Re: Docket No. 461- CSC 461 Greenwich Substation and Line Project
CSC-01 Interrogatories dated 07/30/2015

Data Request CSC-01
Dated: 07/30/2015
Q-CSC-018
Page 1 of 1

COS COB
 PLAN & SECTIONS
 CONNECTICUT SITING COUNCIL
 GREENWICH, CT

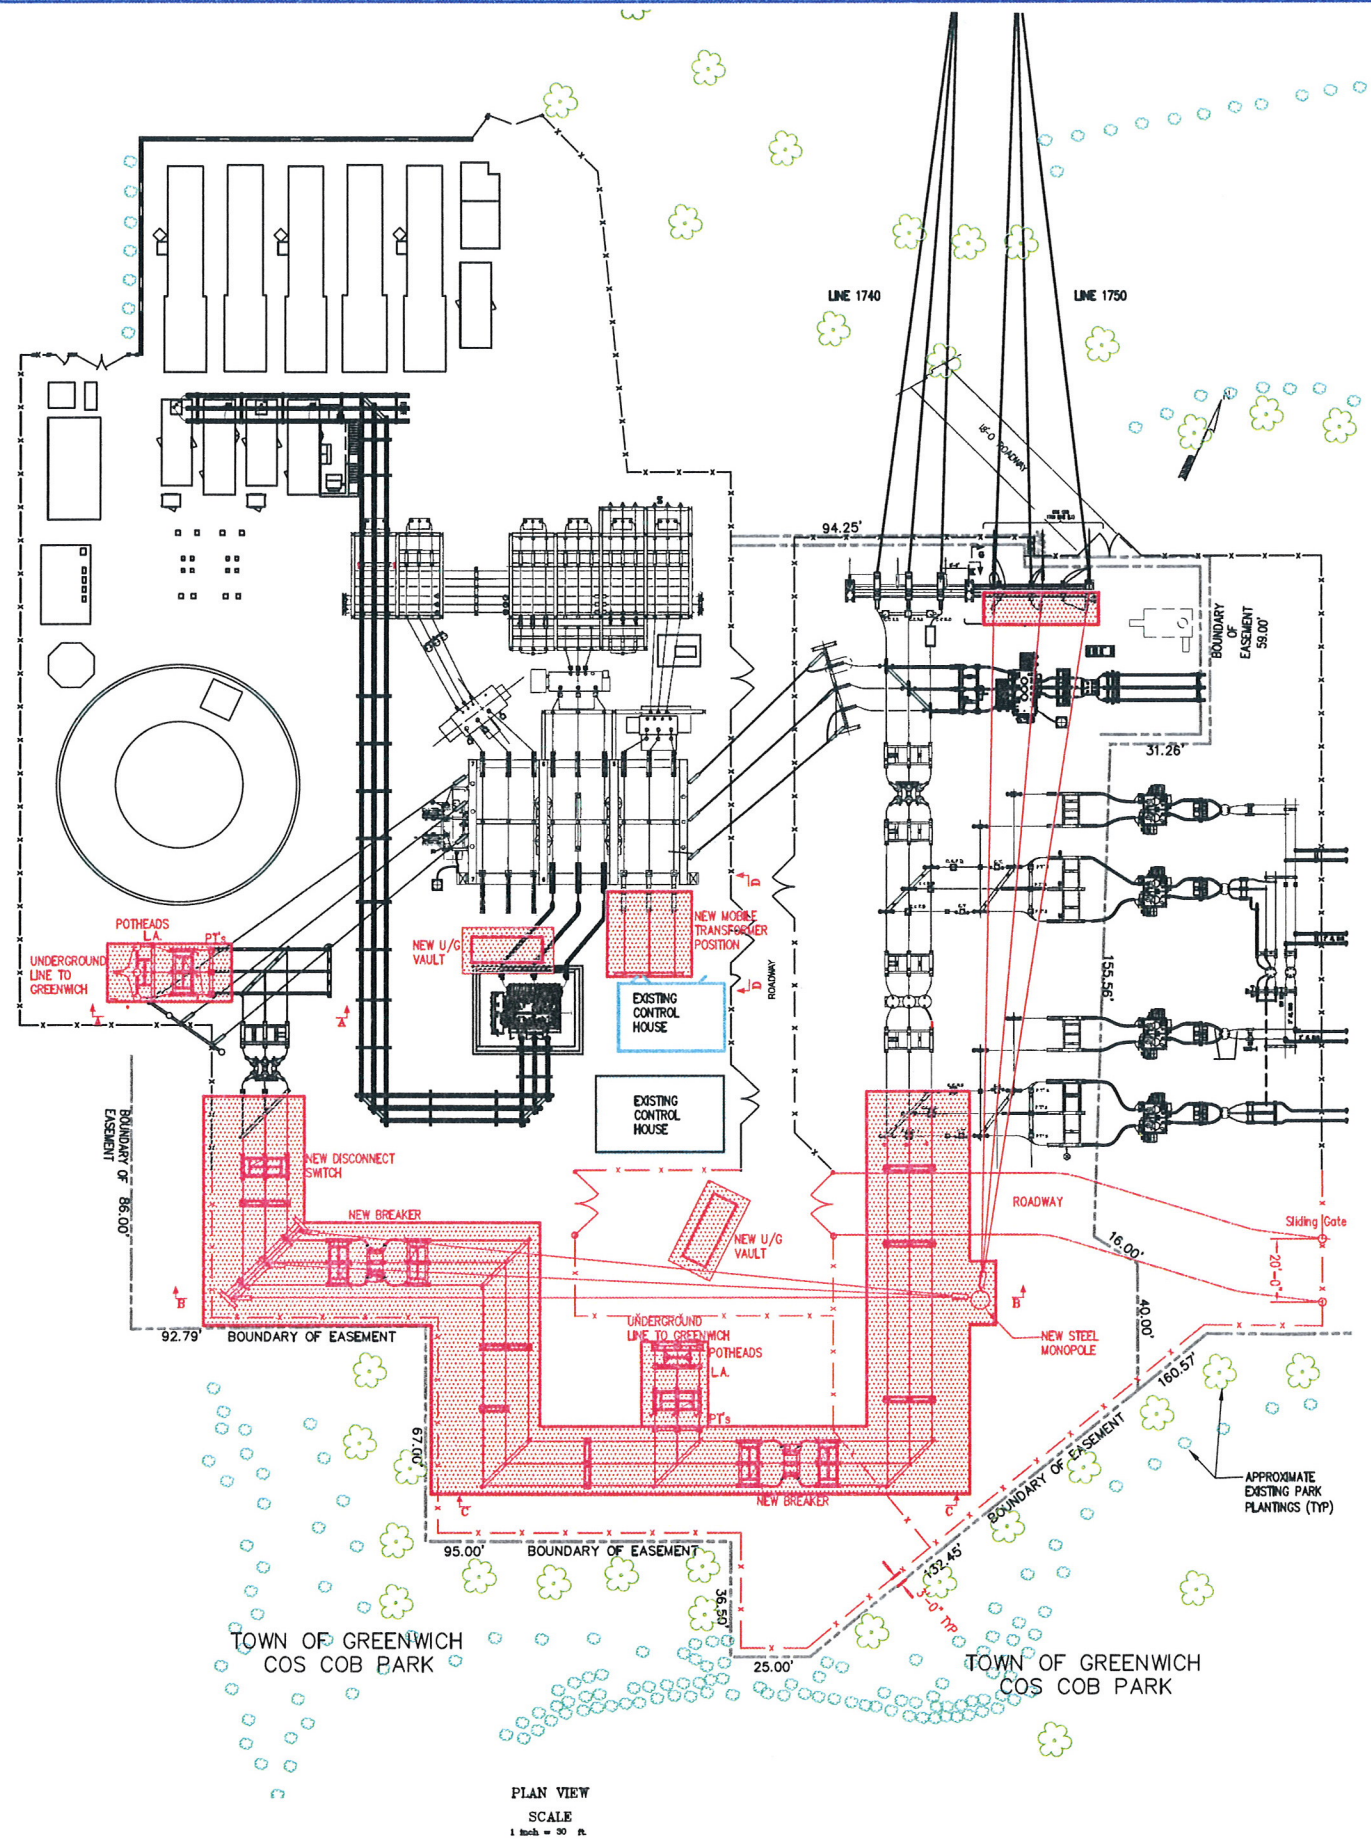
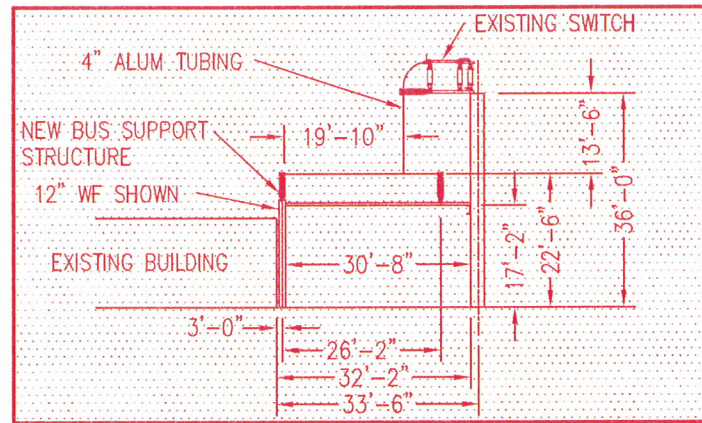
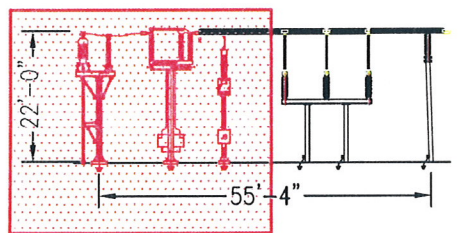
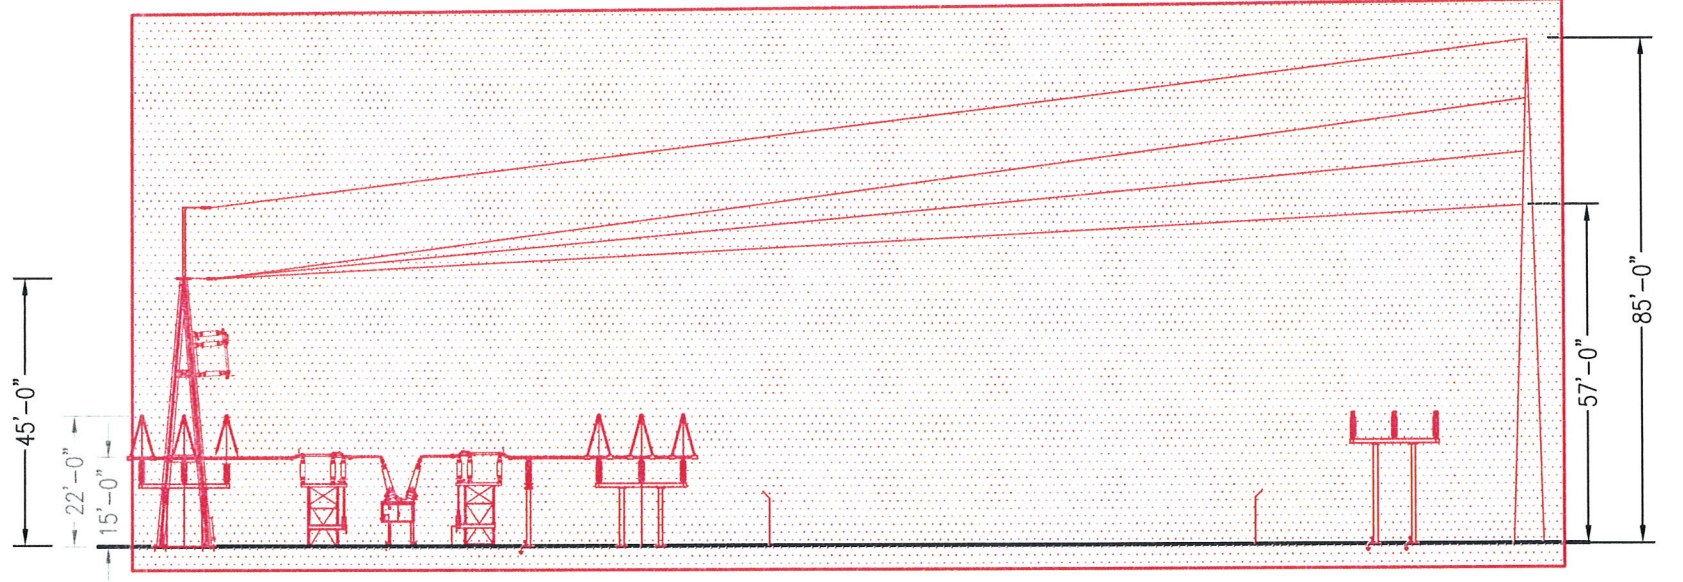
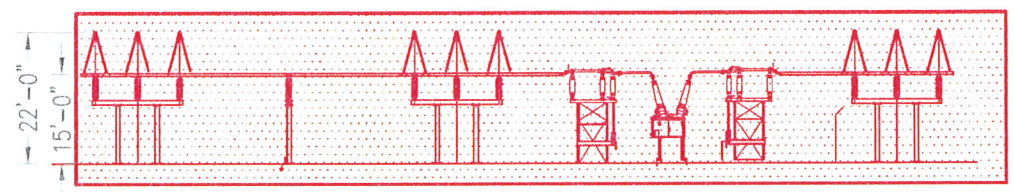
Please resubmit Application Appendix C, Cos Cob Site Plans, with appropriate substation component labels/property lines/vegetation as the plans submitted are difficult to read.

Please see the attached updated Appendix C, Cos Cob Site Plans.
